Landmark Commission

AGENDA

APPLICATION FOR A CERTIFICATE OF
APPROPRIATENESS FOR EXTERIOR RENOVATIONS,
DOOR, OUTDOOR SIDEWALK PATIO, WINDOWS,
SIGNAGE AT 220 EAST WATER STREET.

APPLICATION FOR A CERTIFICATE OF
APPROPRIATENESS FOR EXTERIOR RENOVATIONS
AT 114 WEST ADAMS STREET. THE CARNEGIE
SANDUSKY LIBRARY & THE OLD ERIE COUNTY JAIL

Option: C

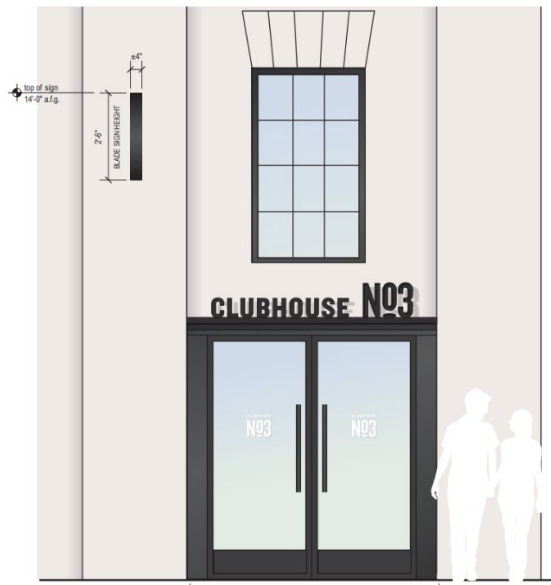
The applicant has come back after further analysis. The sign design and mounting method approved in the 11/17/21 meeting has been updated with concerns from the applicant. The external lighting has stayed the same from the approval.

"In order to mount the said approved sign below (metal tubing structure to create "floating, backlit halo lettering", the contractor said we would need to grind away a large section x2 of the historic limestone facade in order to create a flat mounting area to secure the plates welded to the metal tubing on the front of the building in order to create the strength he needs to hold the tubing up properly"

An option C has been designed as a hybrid of options A & B. Option C has the backlit externally illuminated halo lighting from the approved option B but with the 2D design, colors, layout of option A.

It is staff's recalculation that Commission voted option A down due to the internally illuminated feature, not the overall design. Staff talked with sign provider and confirmed the claim from applicant that approved lettering would require a level surface for application, therefore the historic limestone would need to be sanded smooth in at least three locations for installation. The design with the backing panel can be mounted on uneven surfaces, i.e. onto the existing limestone block, requiring less intervention.

In conclusion, staff recommends the approval of the proposed sign design change at 220 E. Water St. with the following conditions:

1. All applicable permits are obtained through the Building Department, Engineering Department, and any other applicable agency.
2. The lighting is "halo lit" as originally approved (externally illuminated)

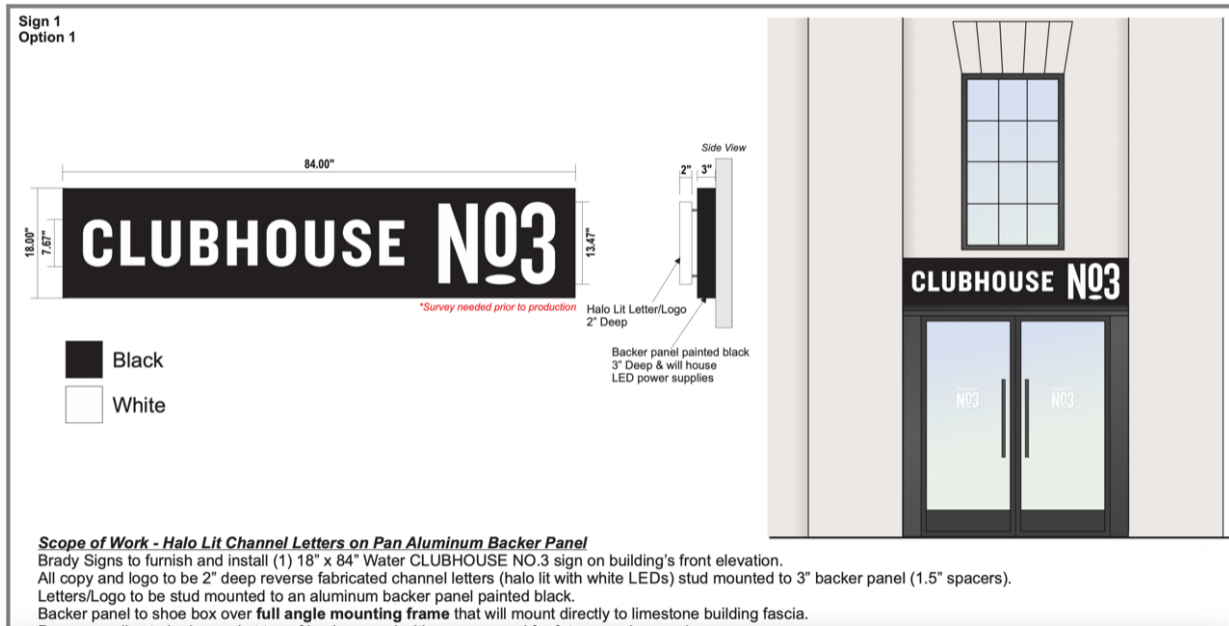
In working with Brady Signs to try to design / manufacture the approved sign, we have some concerns that we are hoping you and your team could help us address. In order to mount the said approved sign below (metal tubing structure to create "floating, backlit halo lettering", the contractor said we would need to grind away a large section x2 of the historic limestone facade in order to create a flat mounting area to secure the plates welded to the metal tubing on the front of the building in order to create the strength he needs to hold the tubing up properly. (Approved design in 2 pictures below)

Brady signs came back and suggested an alteration to the design that would allow them to mount in the most least invasive way by attaching the floating "halo, backlit" lettering that was approved onto a flat metal backer panel that could be then bolted through the building building to the inside

wall. This altered version of the sign (pictured below) would also allow for water to flow naturally behind the sign down the rough textured limestone as it would protrude over the limestone. Would this be an acceptable alteration that could be moved forwards so that we can start the manufacturing process of our sign which will take 8-10 weeks.

PHOTO OF CORNICE TO BE REPLACED

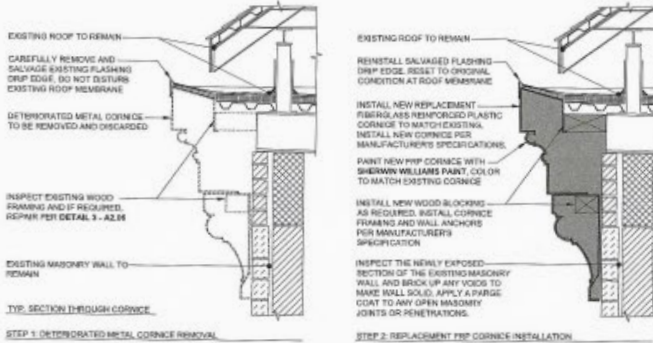
This portion of the project involves the replacement of a piece of dilapidated cornice on the south side of the old County Jail. The proposal is to remove a portion the original wooden cornice and replace it with fiberglass reinforced plastic (FRP) that matches the original look and color.

The architect has stressed that the original wood cornice on this portion of the building is beyond repair and must be replaced. Staff expressed the architectural significance of this building feature and concerns that the portion proposed to be replaced with FRP would be visibly different from the rest of the original wood cornice. The architect explained the replaced portion of the cornice would be painted along with a fresh coat of paint on the remaining wood cornice and be indistinguishable from the historic cornice.

Staff recommends the granting of the Certificate of Appropriateness for the replacement cornice and materials with the following conditions:

1. The new work matches the old design, scale, color, and finish
2. Any salvageable original materials are preserved.

SANDUSKY LIBRARY - ITEM ONE - SHEET METAL TO BE REPLACE WITH BIRD SPIKES

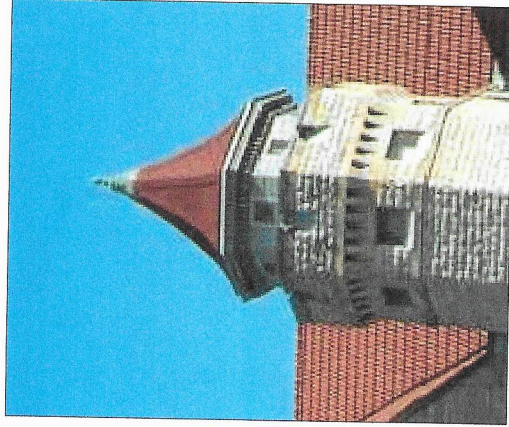
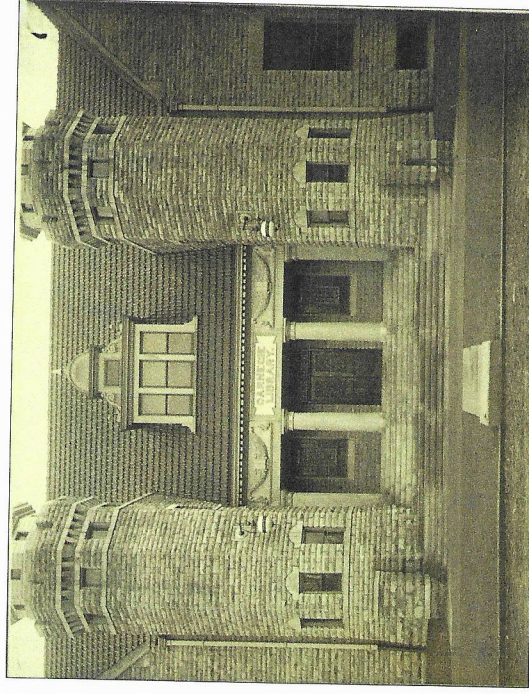
The applicant seeks to replace the sheet metal on the turrets with bird spikes. This includes the slanted square sections on the turrets and along the base of the turret window sills.

The applicant wishes to remove the existing sheet metal due to the fact that they believe birds have begun making nesting sites behind these barriers. They also believe the sheet metal was not original to the building’s architecture; but was added as an earlier intervention to prevent bird nesting. The applicant feels the bird spikes will do a successful job at keeping birds from damaging the historic structure and will better aesthetically match the original condition of the building.

The sheet metal coverings are not believed to be original in design or an original material to the building, and therefore do not count as “distinctive materials” nor contribute to the historic significance of the building. In this instance, keeping birds from damaging the original materials is a priority. Staff is comfortable with the Architect’s recommendation that the spikes will do a significantly better job at preventing damage from birds than the existing sheet metal.

Staff recommends the granting of the Certificate of Appropriateness for the proposed bird spike systems.

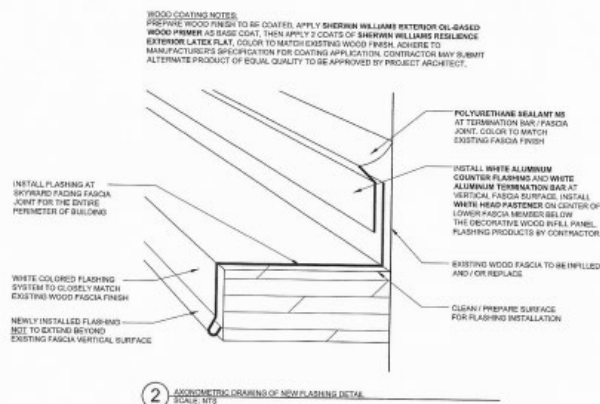
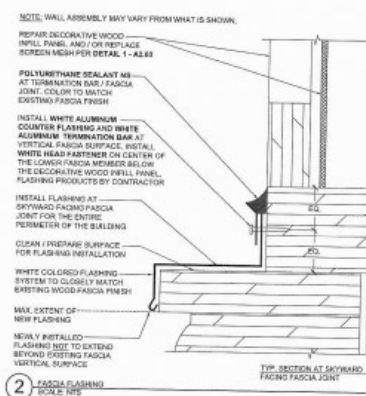
Staff believes this is an original window. It is not visible from the sidewalk or public right of way. Staff expressed concern that the replacement window would change the exterior character of the architecture. The architect expressed the condition of the existing window warrants its replacement rather than repair and ensured the proposed window replacement will match the design and character of the original window including the pattern and location of muntins.

Staff recommends the granting of the Certificate of Appropriateness for the replacement shed dormer window with the following conditions:

1. The new work matches the old design, scale, color, and finish
2. Any salvageable original materials are preserved.

FOLLETT HOUSE MUSEUM - ITEM TWO - FLASHING AT FASCIA

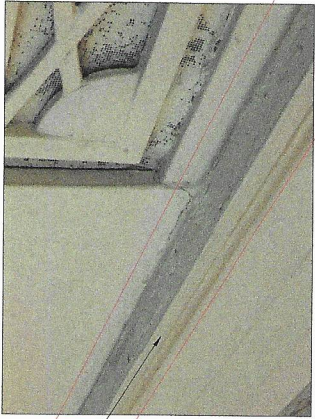
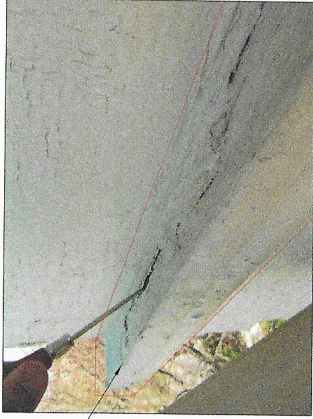
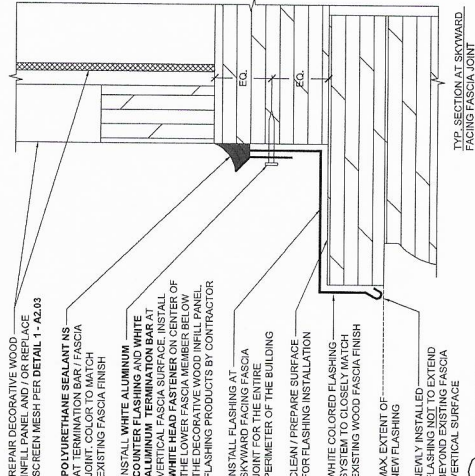
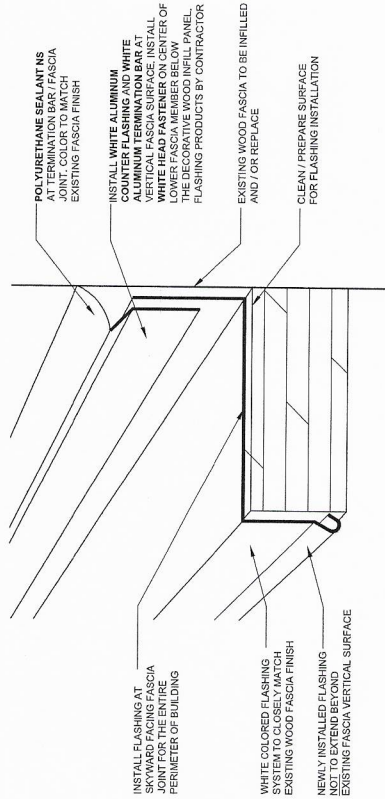
The architect explained the purpose of the added flashing is to preserve the historic wood fascia of the architecture. The current wood fascia has been damaged over time due to water penetration. The existing wood fascia will be repaired and repainted as part of the project. Staff expressed concerns with adding the metal fascia feature that is not original to the building and ensuring the added feature does not change the design aesthetic of the existing fascia—a significant feature of the building. The architect ensured the flashing would be installed with minimal change to the look of the cornice up close, and would be nearly indistinguishable at the street level from the existing condition. They reiterated the value the flashing would add to preserving the original wood fascia.

A remaining staff question is how long the wood fascia would last with only the planned repair and painting in the scope of this project, and without the installation of proposed fascia to protect it.
